Docket Number:	17-AAER-06
Project Title:	Commercial and Industrial Fans & Blowers
TN #:	221241
Document Title:	Morrison Products, Inc. Comments On Notice of Data Availability for Commercial and Industrial Fans and Blowers
Description:	N/A
Filer:	System
Organization:	Morrison Products, Inc.
Submitter Role:	Public
Submission Date:	9/19/2017 2:15:21 PM
Docketed Date:	9/19/2017

Re: Morrison Products Comments on Department of Energy's (DOE) Notice of Data Availability (NODA) for Energy Conservation Standards for Commercial and Industrial Fans and Blowers [Docket Number EERE-2013-BT-STD-0006]

Figure 1 – Fan Curves at Various Speeds Showing Efficiency Change

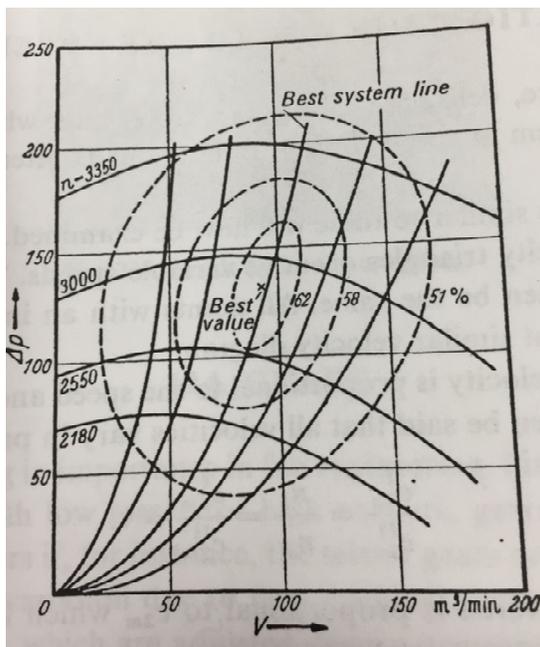
- a) The request by AMCA to use legacy data illustrates that the AMCA data is not per the ASRAC Working Group (WG) agreed upon test conditions and brings into question the validity of DOE analysis that uses this data as a starting point. In the WG term sheet, Recommendation #17 has a defined speed of test as being essentially the average speed between the maximum rated and minimum speed for a given fan. AMCA 210 does not give guidance on speed of test (other than intended operating point for specific design fans) and tests of fans are often done at a variety of speeds for various reasons that may not coincide with the average speed. While the so-called “fan laws” allow minor adjustments in speed to estimate other performance points, they do not account for changes in efficiency that occurs in fans as speed changes (see Figure 1 below). This change in efficiency is seen in all rotating fluid machinery and can be fundamentally described. As the base data used in the DOE analysis comes from unknown test speeds and the compliance bubbles for fans will change with the speed of test, the change in test speed will have varying effect on the operation map and level of compliance. An example for a fan can be seen below in Figure 2. It shows the performance map for a well-designed FC blower with good efficiency. Efficiency changes with test speed result in a variation of the compliance bubbles for the different EL’s.

For the above reasons, DOE needs to start the NODA over and begin with test data that reflects the WG’s agreed upon test method. When adjusting the curve for the other factors stated above, the Department will find the claim of reaching EL5 is not always readily achievable when all factors are accounted for and maybe virtually impossible in many cases.
